## **ADDENDUM #2**

Issued: April 16, 2018  
Closing Date: Wednesday April 18, 2018  
@2:00:00pm Local Time

### **ITEM NO.4 – VARIOUS SIZE WATERMAIN INSTALLATION BY HORIZONTAL DIRECTIONAL DRILLING (HDD)**

**HYDRANTS IN DITCHED AREA**

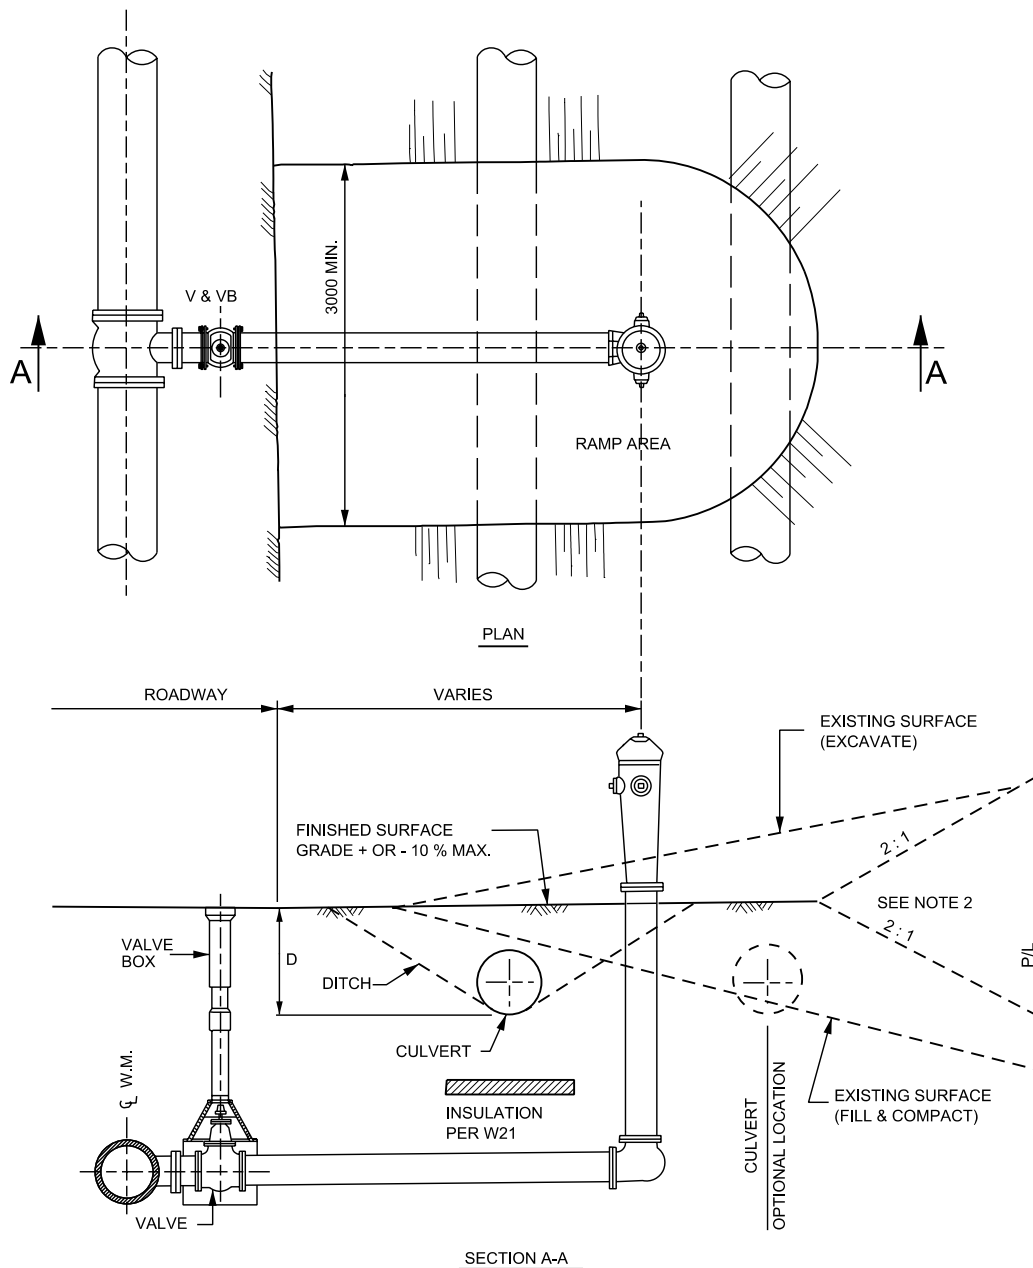
- 4) Are there headwalls on all the culverts at the hydrants? We are unsure what the “boxes” are at each end of the detail.

- 9) **Question:** Can we be provided with a link to the Clarence-Rockland Standards that are referenced?

27) Question: Addendum 1 was saying HDPE culverts to be installed with headwalls? Can you please provide more detail on these headwalls if there are any, as they don't seem to be shown on the drawings?

**Response:** Smooth HDPE headwalls are required at each end of the culvert as indicated.

**Response:** As per addendum 1. New Hydrant and Valve as per standard drawing City of Ottawa W20, Hydrants in Ditched Area - *Appended*.

Response: Headwall inlets and outlets are to be provided for HDPE culverts as indicated on drawings. HDPE Smooth wall headwalls or an approved equivalent are to be supplied and installed.
